Re: FirstLight Hydro Generating Company, FERC Project Nos. 2485 and 1889;
Revised Study Plan 3.3.19, Evaluate the Use of an Ultrasound Array to Facilitate Upstream
Movement to Turners Falls Dam by Avoiding Cabot Station Tailrace

REVISED STUDY PLAN

Study 3.3.19 - Evaluate the Use of an Ultrasound Array to Facilitate Upstream Movement to Turners Falls Dam by Avoiding Cabot Station Tailrace

Appendix A
Stakeholder Comments

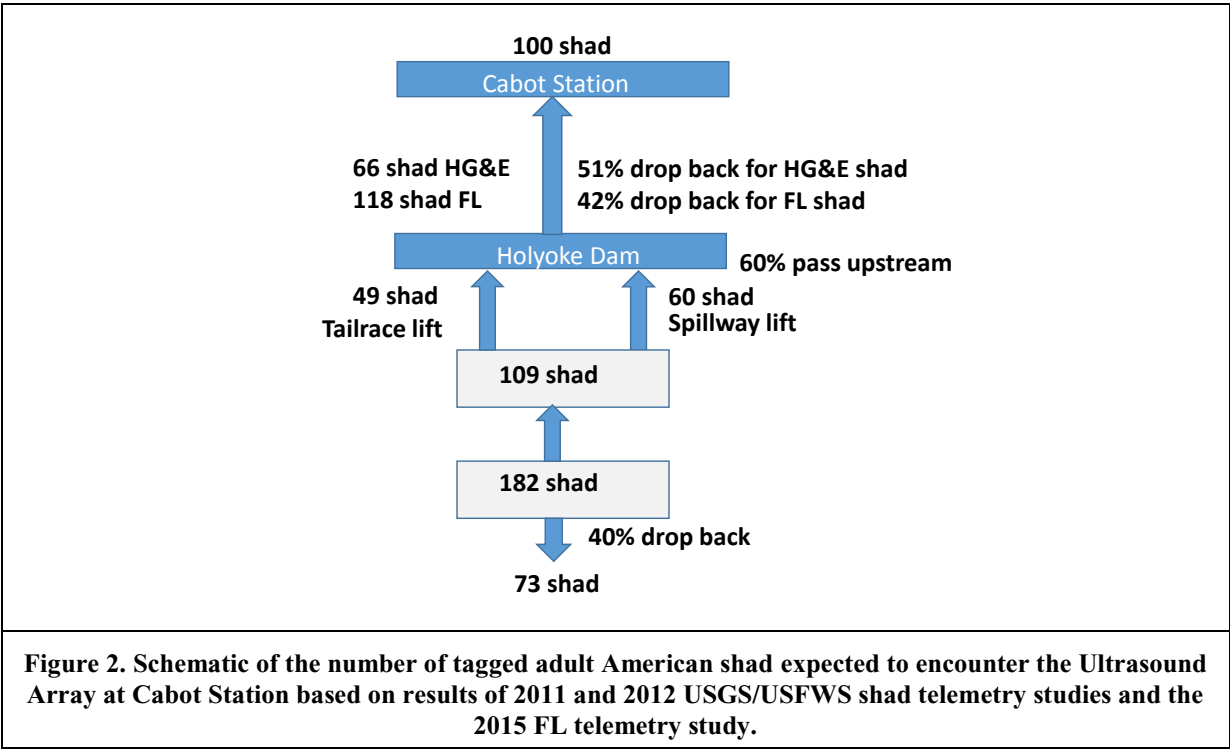
The additional radio antennas at the dam (note under Figure 2) should detect fish in the vicinity of the dam and in close proximity to the spillway entrance. An antenna should also be located at Station #1 to detect any delay caused by the operation of Station #1 and to detect fish movement in the bypass.

Figure 2, showing the number of shad available from the HG&E release, incorrectly assumes that all 109 shad that arrive at Holyoke will pass. Results from the whole river study indicate that 60.7% of lower river released shad that arrive at Holyoke pass. As such, 66 shad from the HG&E release will pass the dam. Using the 0.58 rate of shad tagged at the Holyoke lift, if 100 shad are tagged at the lift 106 would
